CLEPA proposal belt route marking

October 18, 2017.
CLEPA Offices

CRS-64-02e Consolidated R129 rev3 2017-02-15 (new additional text in blue)

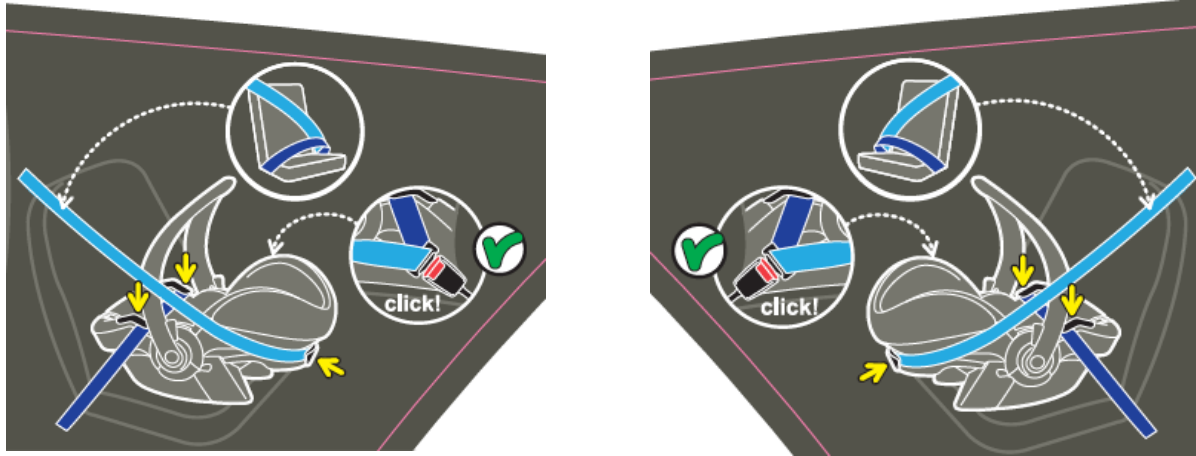
(g) The adult belt path of the shoulder and the lap belt of universal belted and specific vehicle belted ECRS shall be indicated with specific icons for shoulder belt path and lap belt path, visible for the user close to the belt guiding area (icon A & B) or on the installation drawings (icon C). Icon A, B and C shall have the same colour coding like used on the installation drawings and the minimum size is 20 mm in diameter.

Belt routing icon to be used on or near belt guiders

Belt routing icon to be used on installation label
